URGENT FIELD SAFETY NOTICE

GE HealthCare Ref. # 34136

RE: **Aisys CS², Avance CS², Avance CS² Pro, Aisys, Avance, Amingo, Aespire 100, Aespire View, Aespire 7900, and Aespire 7100 anesthesia devices equipped with the Auxiliary Common Gas Outlet (ACGO)**

Figure 1. Covers applied to ACGO Port and ACGO Switch

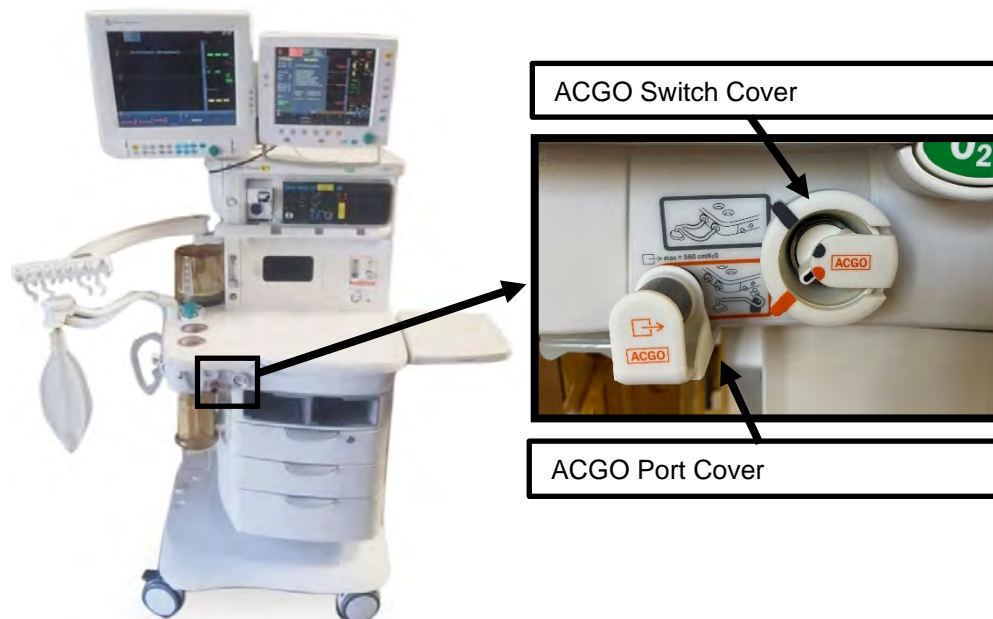
If the expiratory limb of a patient breathing circuit is mistakenly connected to the ACGO port rather than to the Advanced Breathing System port, it can result in excessive pressure within the breathing system. The Anesthesia devices that are potentially impacted have several alarms that would alert the clinician of increased breathing system pressures. However, in the unlikely event that the misconnection to the ACGO port is not noticed, the increased pressure can lead to patient injury.

Inspect all potentially affected devices for the presence of covers applied to the ACGO Port and ACGO Switch as depicted in **Figure 1**. If the covers are available but not on the device, apply the covers as depicted in **Figure 1**.

GE HealthCare will provide a customer-installable kit containing covers for the ACGO Port and ACGO Switch of impacted devices, at no cost to customers who indicate in the attached acknowledgement form that they do not have the covers.
